Access Compliance Report

Public Rights-of-Way

(Curb Ramps)

Intersection ID: 30257	Main Street: BRADEN_DR	Cross Street: GOOSEDOWN_CT	Location: S
ADA ID: 0C6DD50DC974	Ramp Type: BlendTrans1	Initial Pass/Fail: Pass	Overall Compliance: No
Severity Score: 17.75			
Codes/Mitigation Info/Possible Solution		Field Measurements/Component Compliance

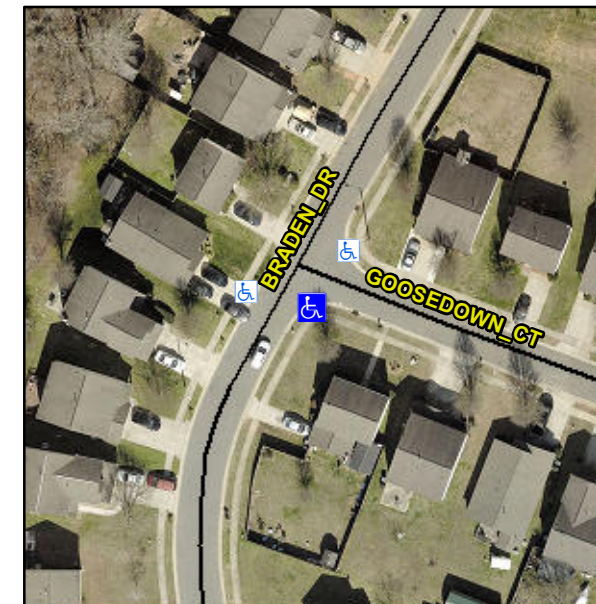
CURB LIP 0.5

Not Found, R304.5.3, R304.2.2-Perp, R304.3.2-Para, R305, R302.7.2

Remove & Replace Curb Ramp With Two New Directional Ramps or Equivalent.
